APPENDIX N

N2
RESPONSE TO LA-CITY LEA COMMENTS
SUNSHINE CANYON LANDFILL CITY-COUNTY JTD
FEBRUARY 27, 2008

RE: RESPONSE TO LA-CITY LEA COMMENTS
SUNSHINE CANYON LANDFILL CITY-COUNTY JTD

RE: **RESPONSE TO LA-RWQCB COMMENTS**
SUNSHINE CANYON LANDFILL CITY-COUNTY JTD

FIGURE D-D3

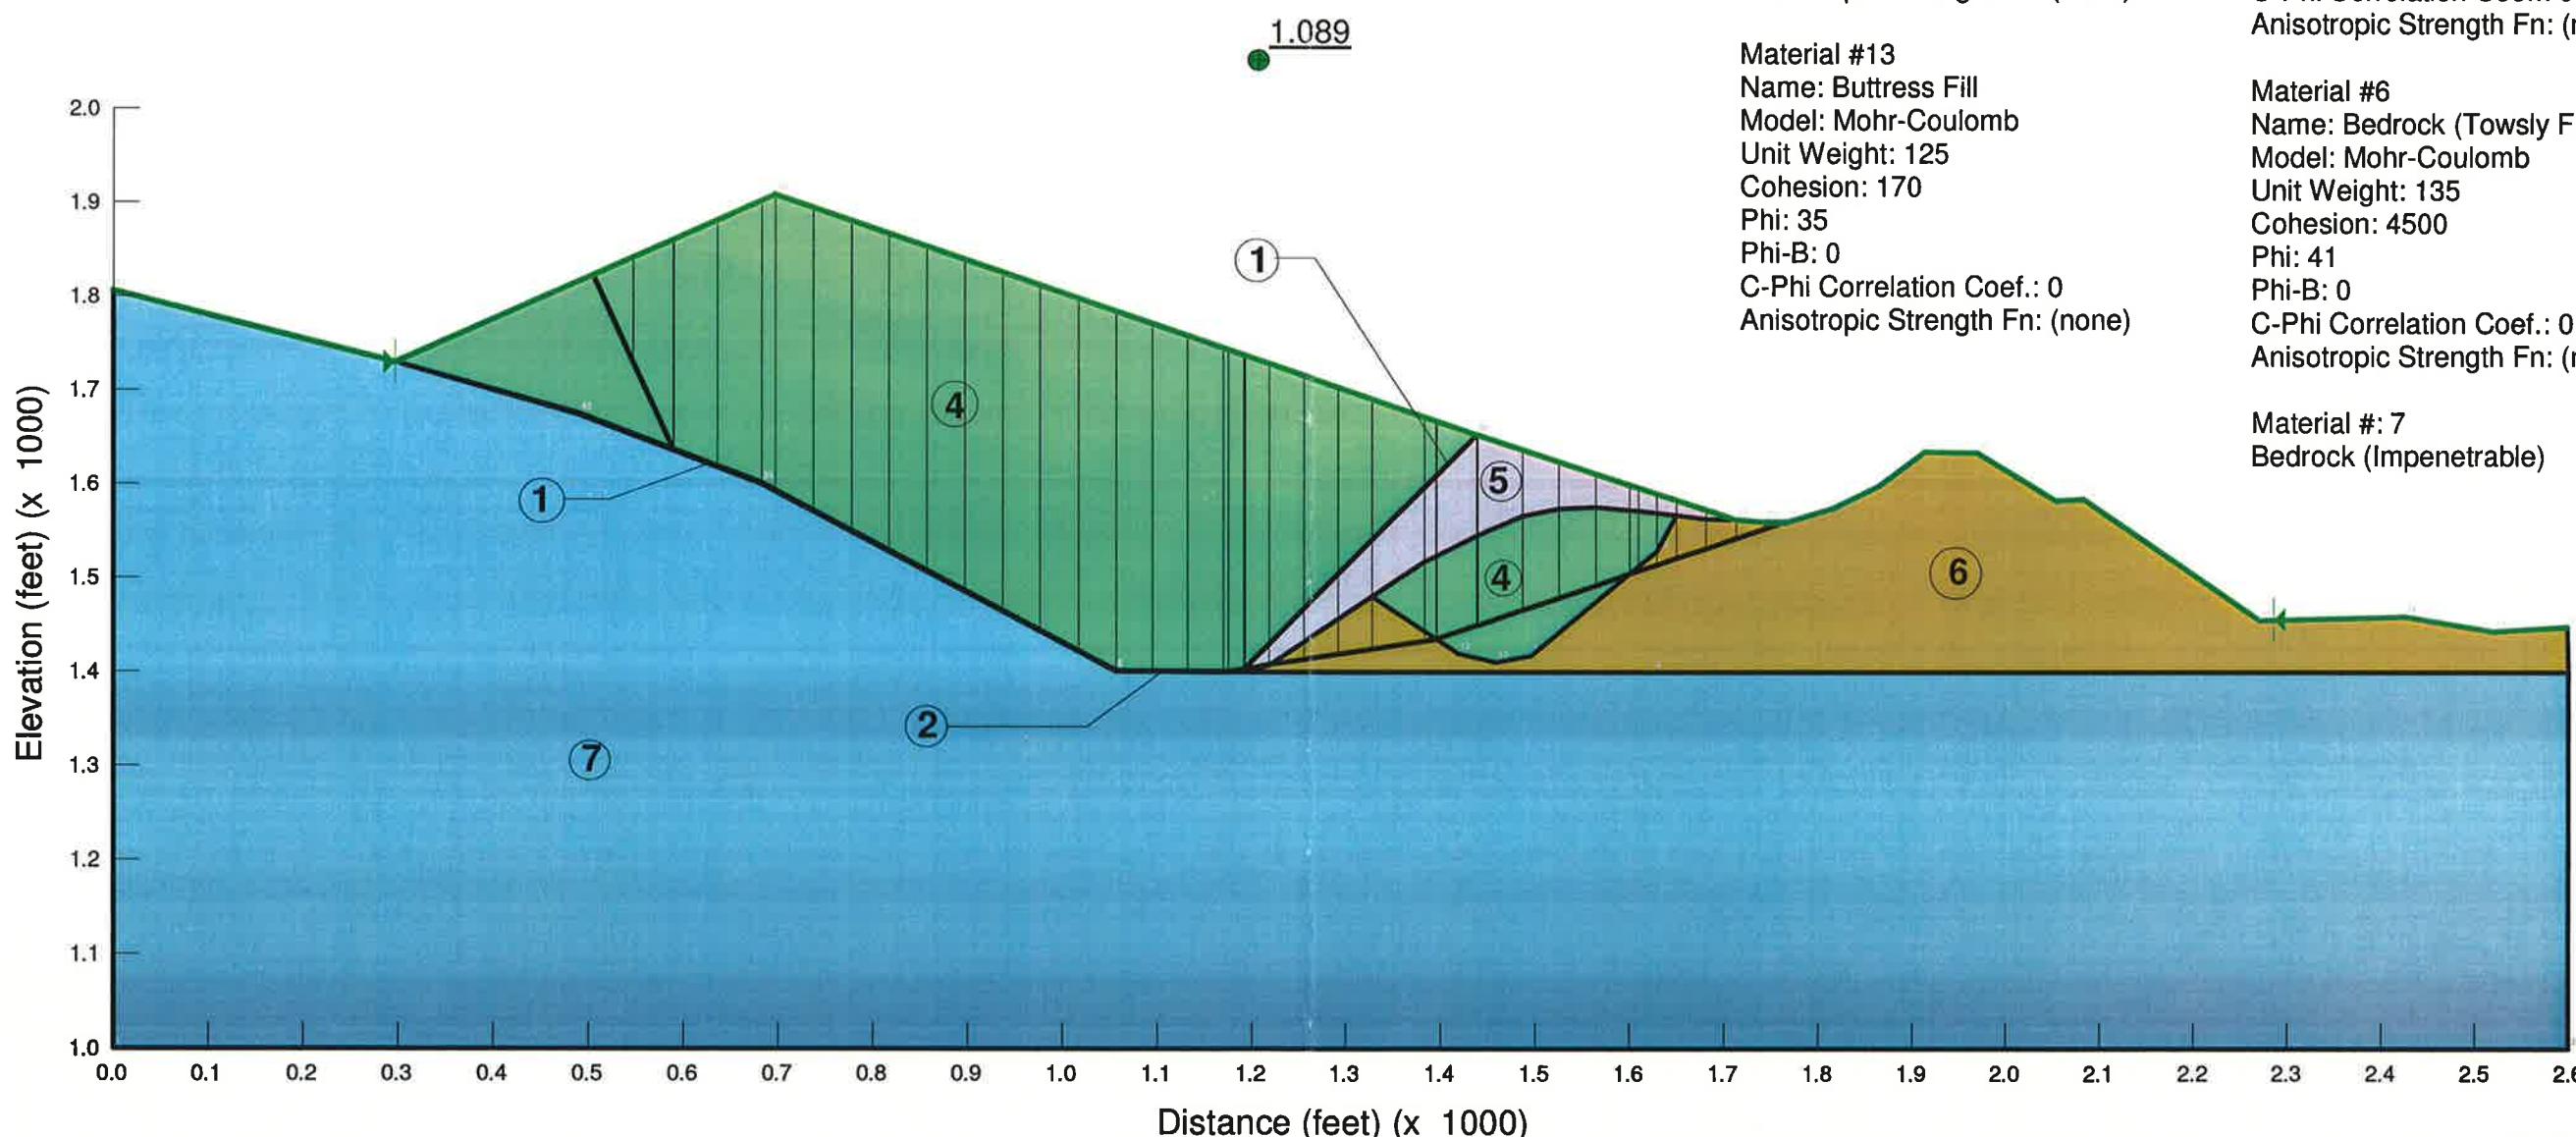
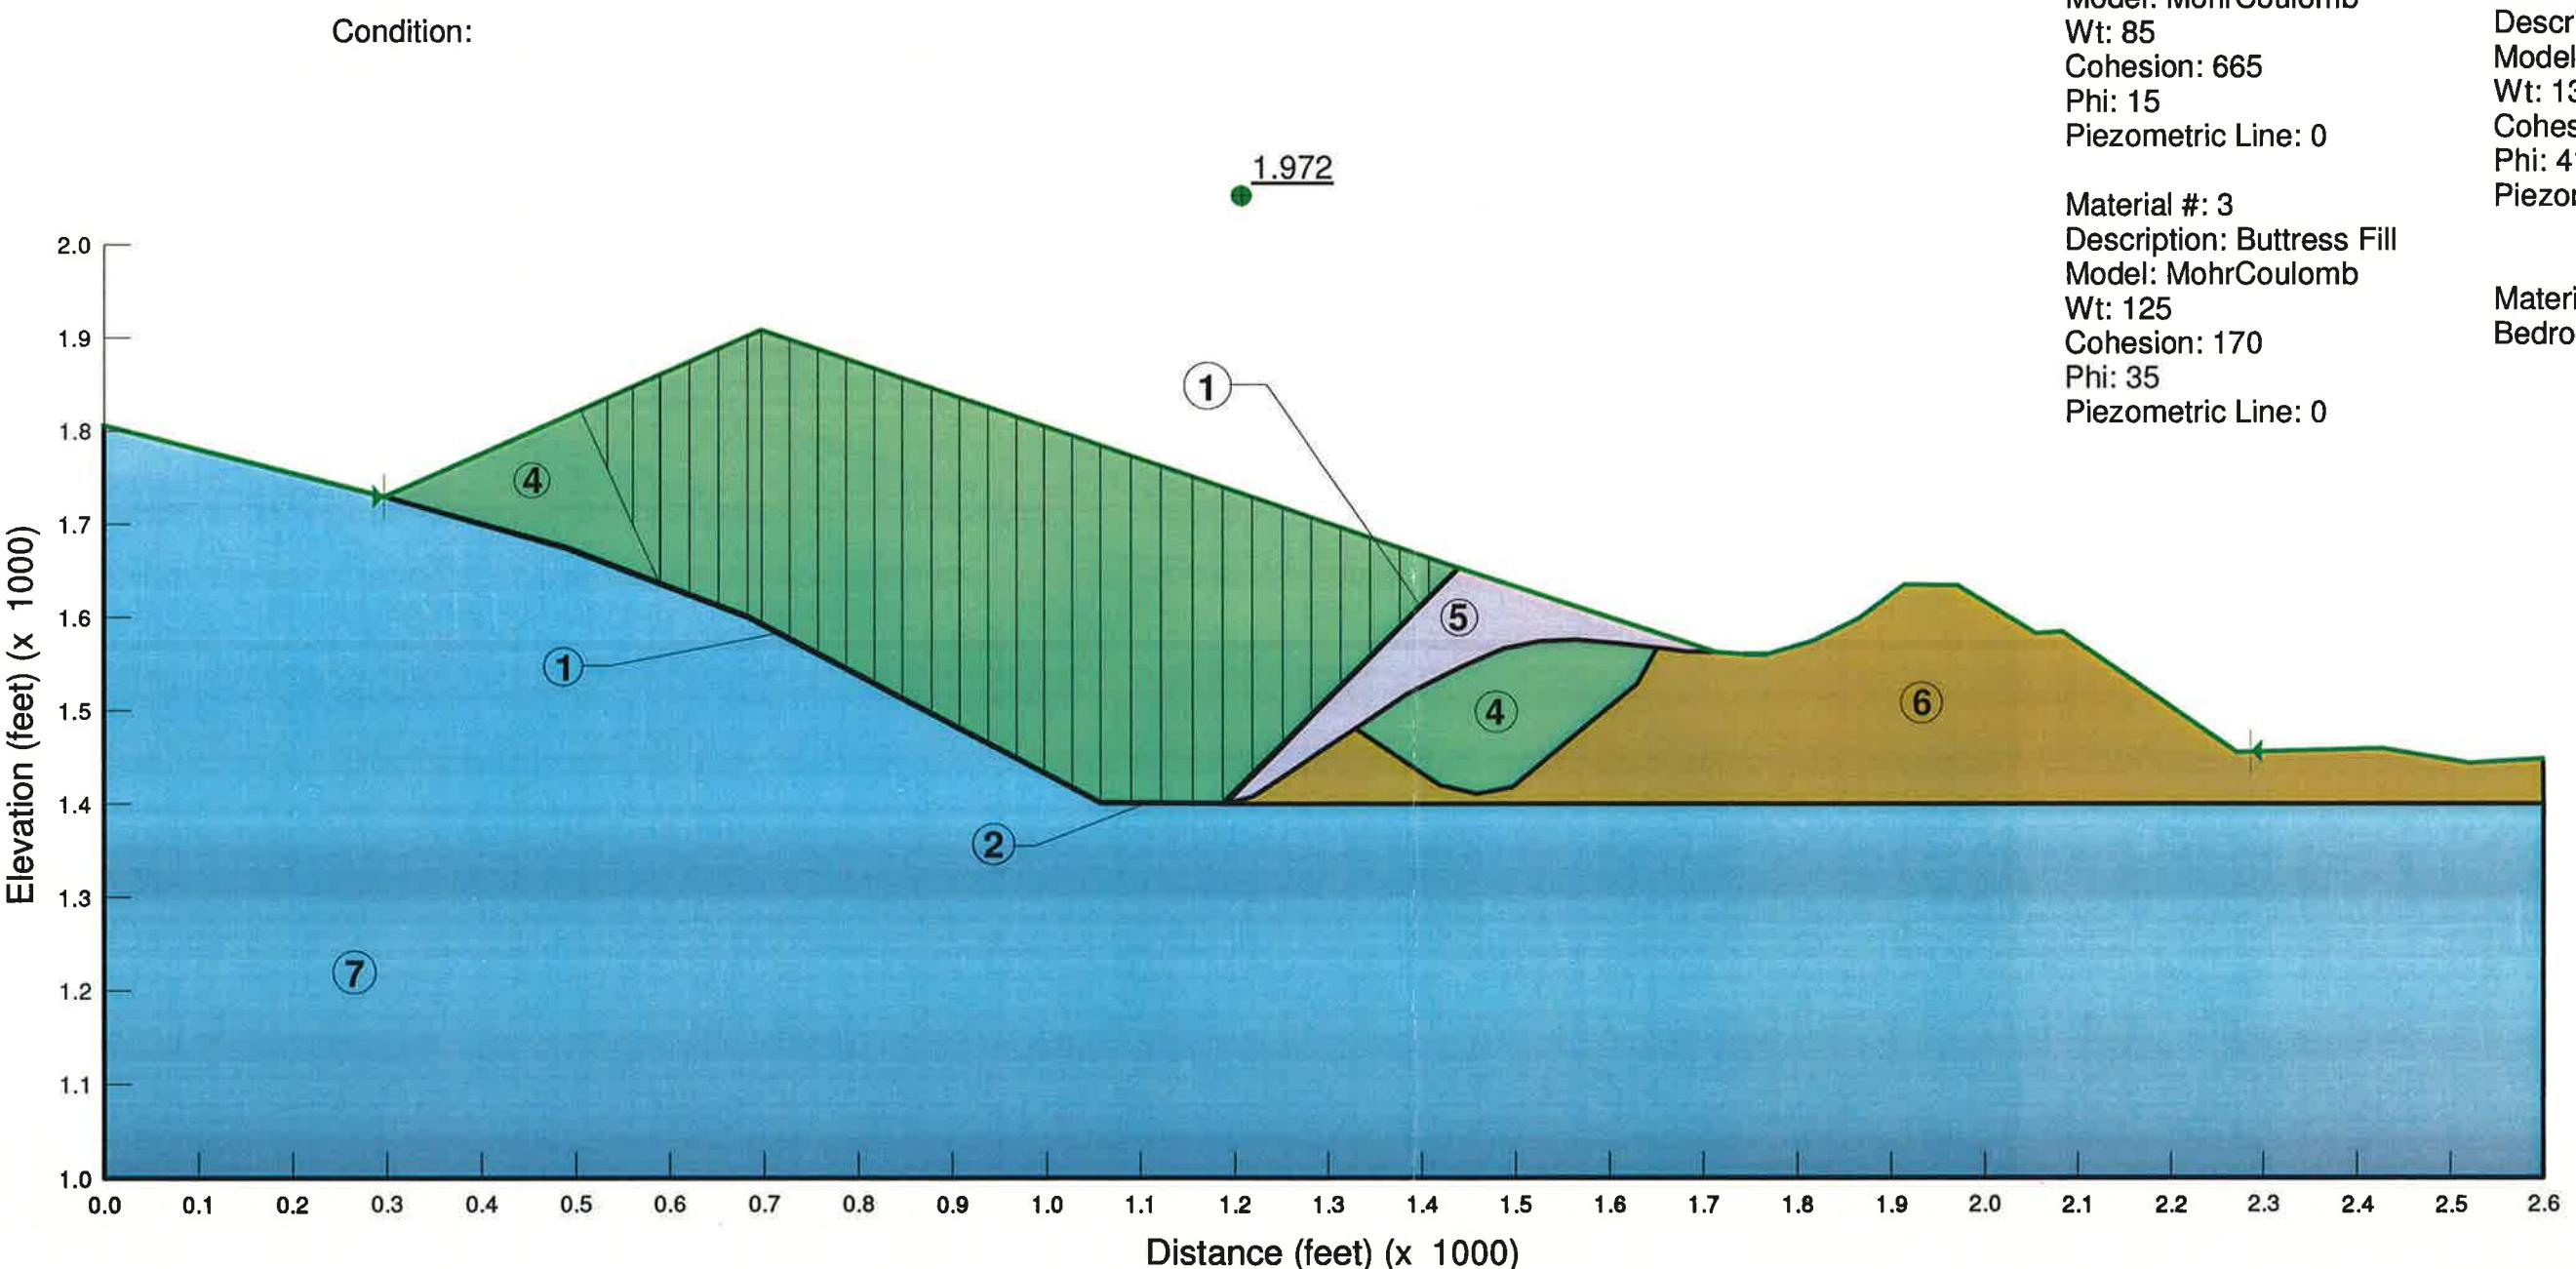
Appendix M, Excavation Slope Stability Analysis and Final Refuse Fill Slopes, Figure 7-6, and Figure 7-7, and Figure 7-8, Section C-C' and Section D-D'; The Section C-C' and Section D-D' slope stability analyses cross section have a stabilizing toe berm which abuts next to "existing topography". The "existing topography" in the area of the previous closed/inactive City Landfill.

Figure 7-7 and Figure 7-8 should show the MSW portion in the cross section depiction. Please differentiate the portions that are soil, and the portions that are MSW. Please also confirm that in the assessment of the slope stability, the modeling took into consideration of the lower density of the MSW at the toe of the proposed landfill expansion."

The newest submission (November 2007, Appendix S) does not have the same slope stability analysis as the previous submission. The current submission's analysis is not applicable to the current proposed expansion. See Figure 13 and Figure 18, and compare to Figure 1a and Figure 1b included in Appendix S (Slope Stability Analysis SCL City) for which the slope stability analysis was performed. The stability analysis was not done on the proposed final contours, and this whole section is inadequate for our analysis and incorrect as written. The current Appendix S is not applicable to the expansion.

Cross Section D-D'

The commenter correctly stated that Cross Section D-D' (Figure 7-8) passes through a portion of the existing inactive City landfill. Based on a comparison of 1987 pre-development topography with the current topography, the extent of existing waste appears to be confined to a northwest-trending canyon which is separated from the access road by bedrock ridge, outcrops of which are currently visible on the surface. As presented in the attached stability analyses for Cross Section D-D', the bedrock ridge interrupts potential failure surfaces that would pass through the existing waste (see Figures D-D1 and D-D2). The static factor of safety for such a potential failure surface is 3.44, and the pseudo-static yield acceleration is greater than 0.67g; note that due to the high value of the actual yield acceleration, the stability analysis software was unable to converge on a solution for seismic coefficients greater than 0.67g (see Figure D-D3).

Recall that in Figure 7-8, the analysis passing through rock at the toe of Cross Section D-D' was the critical analysis, with a static factor of safety of 2.2 and a pseudo-static yield acceleration of 0.28g. Since the results of this analysis were not able to be recreated (and, indeed, the reanalysis proved to be much less critical), the potential liner failure mode was also reanalyzed for Cross Section D-D'. Attached Figures D-D3 to D-D6 present the results of the reanalysis of the liner failure mode; the static factor of safety is 1.97, and the pseudo-static yield acceleration is greater than 0.39g. As above, the stability analysis software was unable to converge on a solution for seismic coefficients

greater than 0.39g, so the actual yield acceleration is greater than this value (see Figure D-D6).

The maximum seismically-induced permanent displacement presented in the 2002 JTD for Cross Section D-D' of about 18 inches was based on a yield acceleration of 0.22g (see Table 7-6). Since the lowest yield acceleration for the reanalyses of Cross Section D-D' presented herein is greater than 0.39g, the estimate of 18 inches of seismically-induced permanent displacement from the 2002 JTD analyses is conservative.
